Ignition unit of ROTAX engine 912 UL

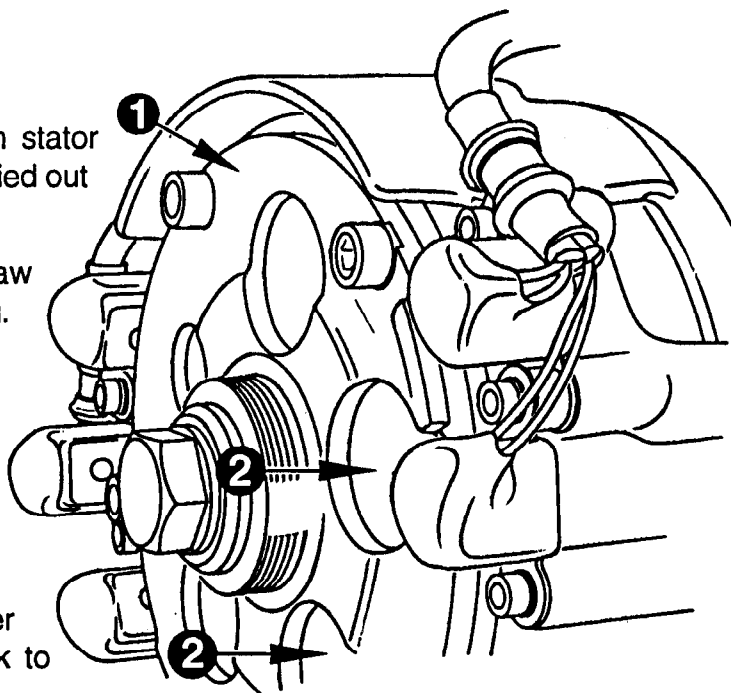
As known from experience, inadequate ground connection could arise between stator and ignition housing on the engine type 912 UL.

Disconnect battery. No need to withdraw magneto housing ❶ with magneto ring. Remove at least 2 of the 4 Allen screws ❸ and lock washers for stator attachment via the openings ❷ in the magneto housing.

Use spot-facing cutter ❹ or similar tool to machine

contact face ❺ on stator for the screws ❸ removed. It is advisable to grease cutting tool to collect chips on cutter and not on magneto ring.

Refit screws M5 along with lockwasher and tighten to 6 Nm. To ensure lasting ground connection treat contact faces for screws with Lithium-base grease.
